RFQ NUMBER
DEP14591

LINE	QUANTITY	UOP	CAT NO	ITEM NUMBER	UNIT PRICE	AMOUNT
***** ADDENDUM NO. 1 *****						
ADDENDUM ISSUED FOR THE NELLIS (BLAYLOCK) PORTAL PROJECT TO DISTRIBUTE THE PRE-BID SIGN-IN SHEETS, THE REVISED SPECIFICATIONS, THE Q/A, AND DRAWINGS AS A RESULT OF THE MANDATORY PRE-BID.						
BID OPENING DATE AND TIME REMAIN UNCHANGED AS 04/23/2009 AT 1:30 PM.						
***** NO OTHER CHANGES *****						
0001	1	JB		962-73		
RECLAMATION: RESTORATION OF LAND & OTHER PROPERTIES

Req # DEP 14591
Nellis (Blaylock) Portal
Addendum #1

REVISIONS TO SPECIFICATIONS

**TYPICAL V-DITCH
6' RIPRAP CHANNEL**

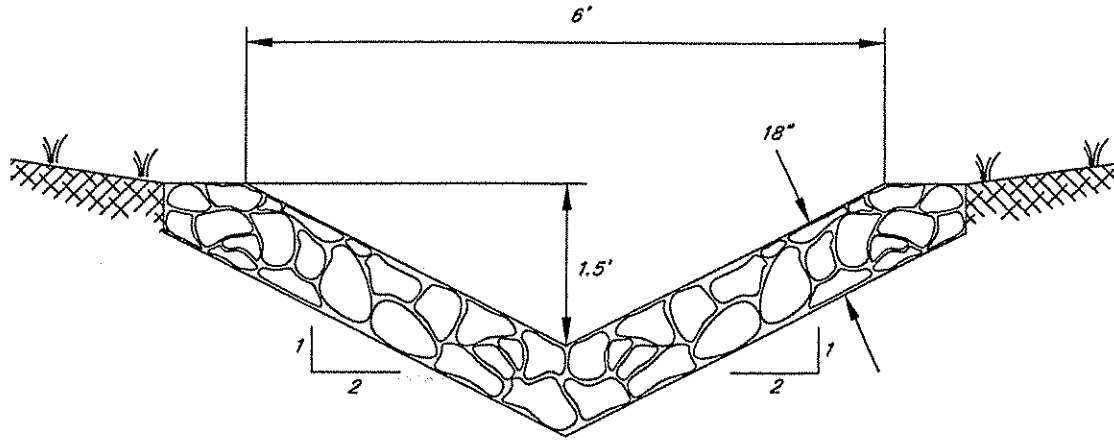
Sheet 4 of 6 – Delete the TYPICAL V-DITCH 4' RIPRAP CHANNEL detail drawing. A new detail drawing of the rock rip channel showing the channel to be 1.5' deep and 6' wide v-ditch is attached.

**PIPE BEDDING DETAIL
(GRASSED AREAS)**

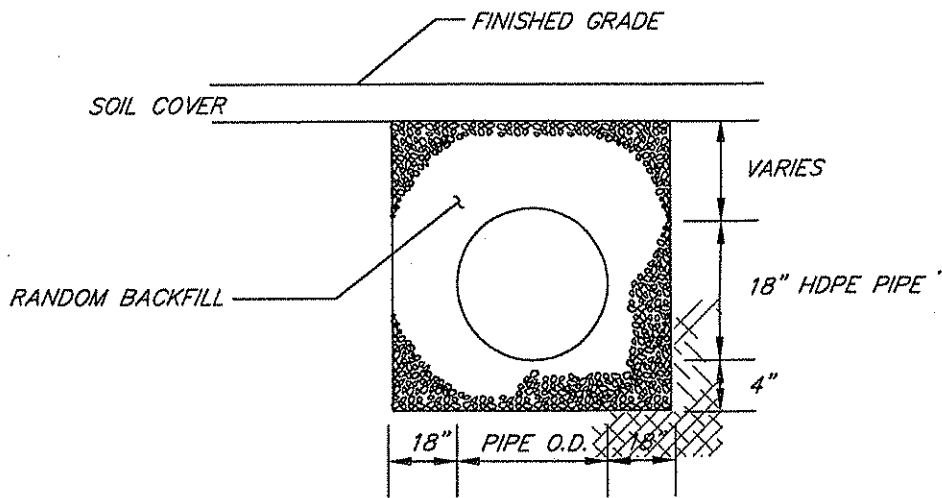
Add 7.2.4 Random Backfill – Random backfill shall be as specified in Section 604.8 of the WVDOT Standard Specifications for Roads and Bridges. The backfill considered for use must first be visually approved by the WVDEP.

A detail drawing of pipe backfill utilizing random backfill is attached.
